REQUEST FOR ADDITIONAL INFORMATION
ELECTRIC POWER RESEARCH INSTITUTE REPORT
Topical Report MRP-169
NUCLEAR ENERGY INSTITUTE

Figure 1. Time to Failure of Alloy 182 in Primary Water as a Function of Stress [4]

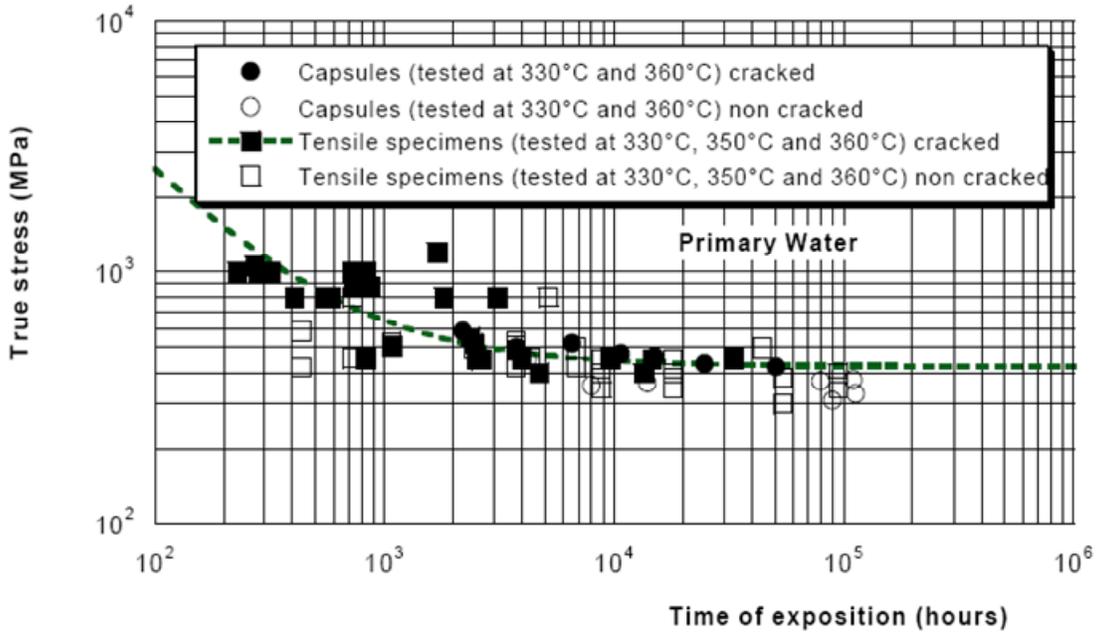
The NEI's response does not provide sufficient basis to demonstrate that increasing the wetted surface stress limit to 10 ksi would be equivalent to the staff position. The statement that stress corrosion cracking will not initiate on a surface that is below yield stress is not a sufficient basis for this conclusion due to large uncertainties in attempting to precisely model the wetted surface condition of in-service DM welds. Please provide additional basis, including supporting data, analyses and operational experience, to support allowing a wetted surface stress threshold of 10 ksi.

A significant body of data exists demonstrating a clear justification for the concept of a threshold for PWSCC initiation in Alloy 600 and its weld metals Alloy 82, 132 and 182. [5 – 8] That is, there exist well-documented temperature, impurity concentration in the coolant and stress limits, below which SCC initiation is extremely difficult and is essentially of no engineering significance. Reference [6] defines such limits for Alloy 600 base metal. Reference [5] presents data from two types of tests of PWSCC initiation in Alloy 182 weld metal, as illustrated in Figure 1. These data exhibited no

failures at stress levels less than 400 MPa (~58 ksi). Based on these data, Reference [5] concludes that "Alloy 182 is susceptible to stress corrosion cracking in PWR primary water only if the applied stress exceeds the yield stress". Reference [7] presents similar data from pressurized cylinder experiments illustrated in Figure 2. On the basis of these data, Reference [7] concludes "A relationship between hoop stress and time to leakage was determined from which a threshold stress limit near 400 MPa (~58 ksi) for PWSCC initiation was determined." Finally, Reference 8 presents crack growth rate data for microcracks initiated in two different types of crack initiation specimens. Although reported as crack growth data, the experiments were actually crack initiation tests, since the crack growth rate was computed based on failure time divided into thickness of the thin walled specimens tested under uniform stress conditions. Samples were tested at stress levels down to 325 MPa (~47 ksi), and at that stress level, the crack growth rates were so slow as to be of little engineering significance (0.03 mm/yr). The 10 ksi limit is thus 18% to 22% of the minimum measured stresses at which PWSCC initiation has been observed in Alloy 132 and 182 weld metals in these laboratory experiments. Therefore, this limit ensures a very low probability of initiating new PWSCC cracks after weld overlay application; with significant margin to allow for uncertainties that may occur in attempting to precisely model the magnitude of tensile stress on the wetted surface of in-service DM welds.
